1992 Eclipse

TECH TALK

Volume 196, April, 2013

TIN-13-42A-001: OUTLANDER SPORT TPMS SENSOR - TEMPORARY PRODUCTION (REVISED) — 2013 Outlander Sport/RVR. TIN-13-42A-001 was sent to all dealers on February 1, 2013 and states:

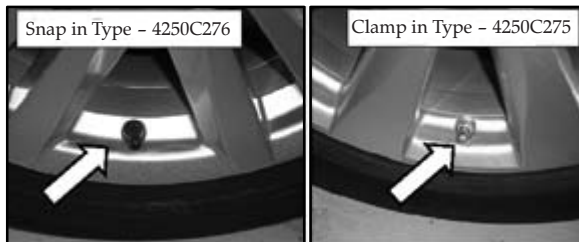
Due to a supply issue with the “snap-in” type Tire Pressure Monitoring System (TPMS) sensor, subject vehicles are temporarily being built using the 2012 “clamp in” type sensor. This change will affect production and service parts until the supply issue is resolved. An owner’s manual addendum card reflecting this change has been placed in the glove box of affected vehicles.

The TPMS sensor type can be easily identified by the valve stem.

This change will result in p/n 4250C276 being temporarily superseded to p/n

4250B975 in the service parts system. Once p/n 4250C276 becomes available, the supersession will be broken, allowing supply of both part numbers. If a replacement sensor is required, install p/n 4250B975. If a customer comments about the cosmetic difference, advise them the original specification sensor can be installed, at no cost to them, when inventory becomes available.

TIN-13-51-001: 2013 OUTLANDER, LANCER AND LANCER SPORTBACK- FRONT LICENSE PLATE HARDWARE ELIMINATED (REVISED) 2013 Outlander, Lancer and Lancer Sportback. TIN-13-51-001 was sent to dealers February 6, 2013 and states:

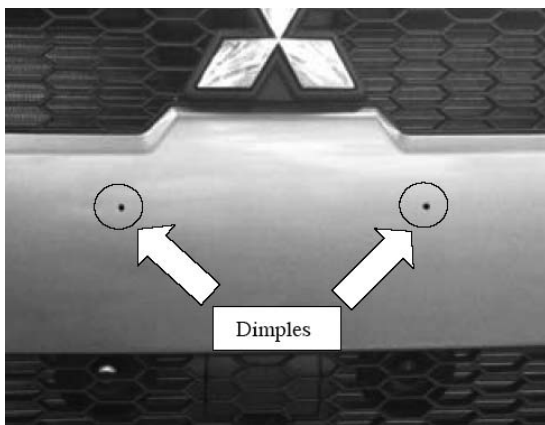
“This notice replaces TIN-12-42A-002 issued November, 2012, to change the minimum length of recommended M6 fasteners.

Affected vehicles are no longer shipped with front license plate hardware (rubber nut and bolt package). Dealers are asked to use self-tapping screws for mounting the front license plate. License plates should be installed in the locations indicated by dimples in the front fascia. Dealers should use locally sourced, non-corroding, M6 fasteners, 20mm to 25 mm long. **Fasteners should be installed using hand tools only.**

REAR SPOILER/TAILGATE RUB MARKS — 2011 to 2013 Outlander Sport/RVR w/factory installed rear spoiler. MMNA is investigating the cause of rub marks in the paint at the contact point between the factory installed rear spoiler and tailgate.

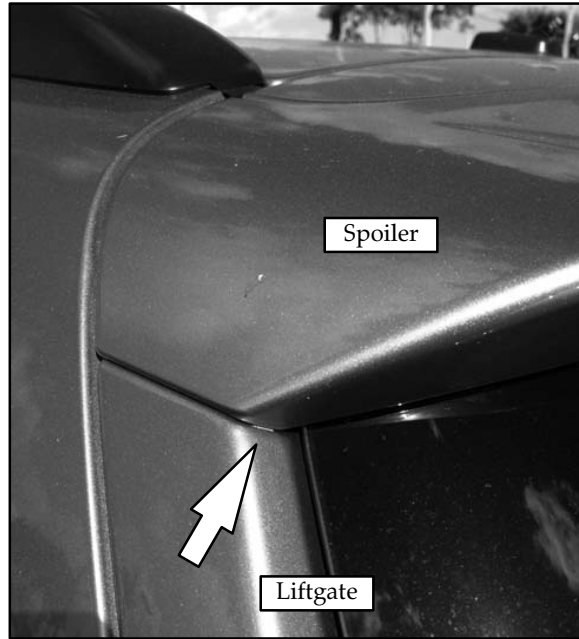
Do not replace the spoiler for this condition. Look for an upcoming publication to address this concern. In the meantime you can contact Techline for the latest information.
